PROJECT DESC: 2022-005033-HDRB. Addition, portal replacement, window and door alterations. Exceptions were requested for window and door alteration on primary facade and for adding on less than 10' from a primary facade.

CASE NUMBER: 2022-005033--HDRB

LOCATION: 964 ACEQUIA MADRE
Santa Fe, NM 87505

This is to certify that the Historic Districts Review Board (HDRB) acted on your request at their hearing on May 10, 2022. The decision of the Board was to approved the project as submitted finding that the applicant's responses to all of the exception criteria satisfies the Board's concerns.

Figure 1: 1984 HBI survey photograph (above) compared with recent image of Front (north) elevation.

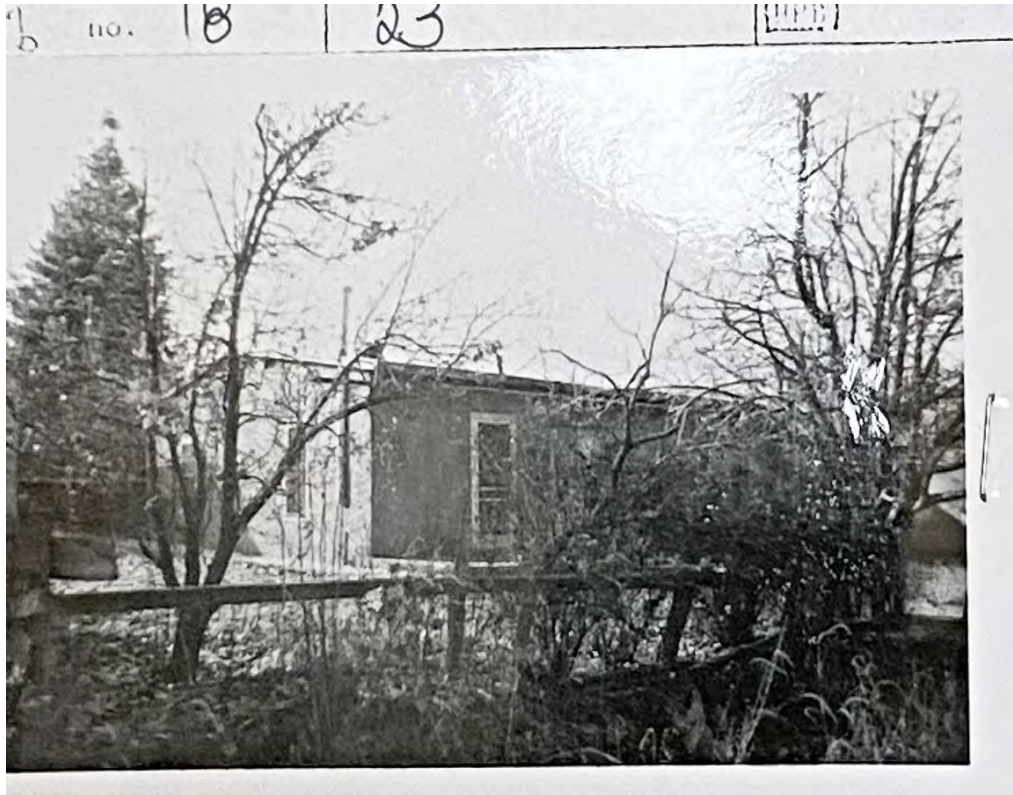
Chair Rios said the photo in the packet from John Murphy shows the house prior to porch construction. John Murphy indicated the door was moved to the west but after studying the photographs, she disagreed. She thought the photographs were taken from different angles and the door has not been moved. She could see a reflection of the light from the windows in the old photograph and why would someone move the door a few inches.

Member Biedscheid noted the photograph is page 16 of the packet.

Chair Rios referred to the bottom picture where the house appeared longer. She thought the photos were taken from different angles.

Vice Chair Katz said it was hard because you cannot see the western portion of the façade.

Christopher Purvis, 518 Old Santa Fe Trail was sworn. He said he and John had discussed this door at length. He said he used a graphic trick and turned the top photograph on its side. The door appeared to go past the end of the building. When doing the same thing on the lower photograph, it doesn't and looks like it has been moved 3 feet. There isn't any way to know unless the structure is tested. He noted on the back side is a heater.

MOTION: In Case 2021-004608-HDRB, 964 Acequia Madre, Member Biedscheid moved to designate the east façade, number 2, as primary, excluding the side portion of the portal that appears on that facade, and the north façade number 1, excluding the portal and all non-historic windows, doors, or openings as to be determined by further assessment. Vice Chair Katz seconded the motion.
